Tech Tip #012

Improved Universal Axle Tool Assembly Instructions

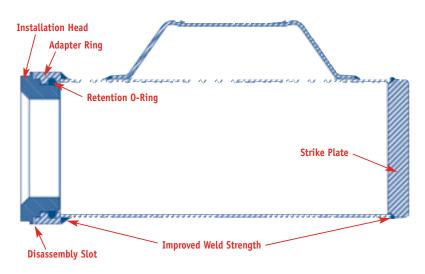
The STEMCO Universal Axle Tool (555-0001) has been redesigned for improved usage and durability. The new tool features an integral o-ring for head retention, in place of the old wave spring and key-plate. The o-ring makes head interchangeability simple and robust, and can be replaced when

worn-out, giving a used tool new life. Additional benefits include improved head retention during seal "bottoming", reduced vibration, and reduced noise. The new retention system has been designed to be compatible with heads already in use by the customer. Weld joint strength has also been improved, making the tool last longer without failure. The new retention design requires a different assembly method for interchanging heads. Please refer to the instructions and pictures below.

- 1. Begin by placing the tool, open-end up, on the floor.
- 2. Place the head into the tool opening.
- 3. Using both hands, snap the head into the tool by applying firm downward force to first one side of the head and then the other. A distinct ringing snap will be heard if performed properly. **NOTE:** A slight gap between the head and adapter ring is normal. This slot is used for disassembly as described below.
- **4.** Lubricant may be periodically applied to the o-ring to aid head assembly.
